# UNITED STATES PATENT AND TRADEMARK OFFICE

APPLICATION NO.	FILING DATE	FIRST NAMED INVENTOR	ATTORNEY DOCKET NO.	CONFIRMATION NO.
10/757,322	01/14/2004	Paul W. Luebke	15352/18	3514

<b>Office Action Summary</b>	<b>Application No.</b> 10/757,322	<b>Applicant(s)</b> LUEBKE, PAUL W.	
	<b>Examiner</b> Tho v. Duong	<b>Art Unit</b> 3753

FIGURE A: THE MODIFIED FIGURE CORRESPONDES TO FIGURE 2 WITH LIMITATION SHOWN.

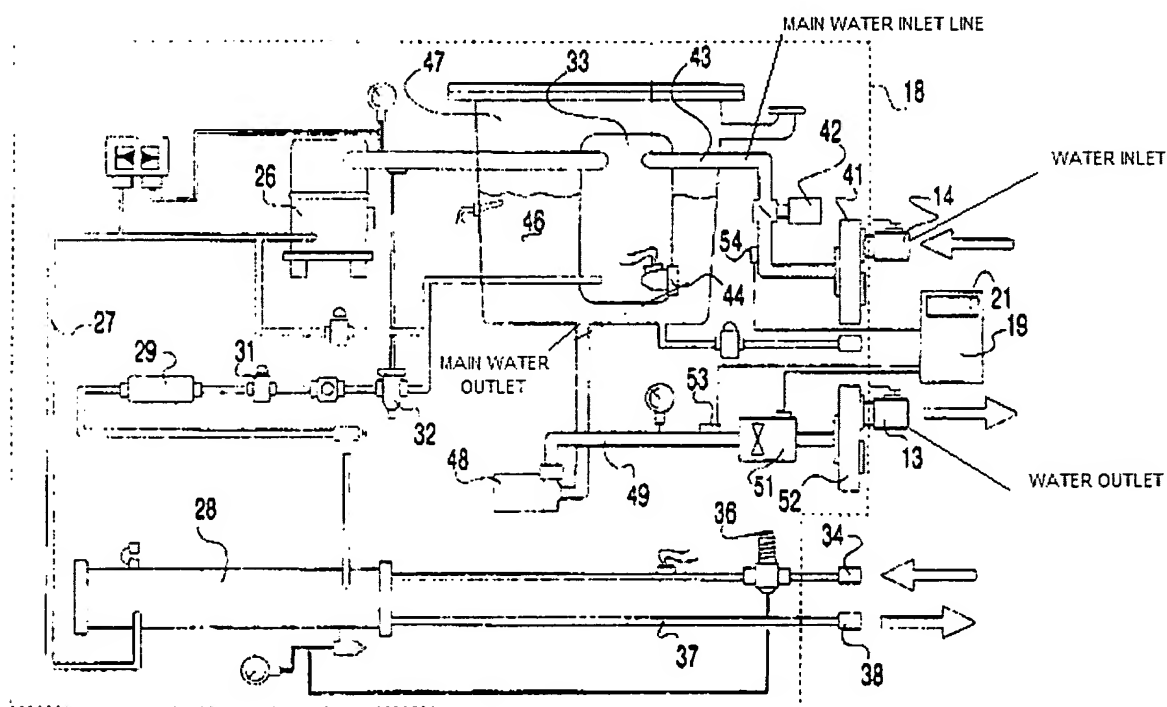
(US 5,761,916). Oswalt discloses (figures 1-2) a modular cooling system for cooling a manufacturing process machine, the cooling loop system comprises a movable chassis (18) having wheels (22); a coolant piping loop mounted on the chassis; a pump (48); a main coolant inlet (outlet of reservoir 47 leading to pump 48) configured to connect to the chilled water system; and at least one coolant inlet ( at valve 14) configured to connect to the manufacturing process machine (12); a main coolant outlet (43) configured to connect to the chilled water system; and at least one coolant outlet (at valve 13) configured to connect the manufacturing process machine; a flow sensor (51) for measuring coolant flow in the coolant piping loop; a flow control valve (13,14,42) for controlling the flow of fresh coolant into the coolant piping loop; the cooling piping loop configured to recirculate coolant through the coolant piping loop and the manufacturing machine (12); a controller (19) mounted on the chassis and operationally coupled to temperature sensors, the flow sensor and the flow control valve. Regarding claim 4, Oswalt further discloses (column 4, line 1-13) that the cooling loop system further comprises a first temperature sensor to measure the temperature of the incoming coolant from the chilled water system ( water at outlet of the evaporator); a second temperature sensor (53) to measure

the temperature of the coolant before entering the machine (12); and a third temperature sensor (54) to measure the temperature of the coolant leaving the manufacturing process machine; a pump controller (the flow display section has “pump on”, “start”, “stop”, “up” and “down” features, which inherently is a pump controller. Regarding claim 8, the main cooling water inlet line, cooling water outlet, cooling water inlet; and main water cooling water outlet are shown in figure A (bellow), wherein the main cooling water inlet line comprises a temperature sensor (54), the second temperature sensor ( 53) located upstream from the water outlet; the third temperature sensor (described in column 4, lines 6-7) located down stream from the water inlet.
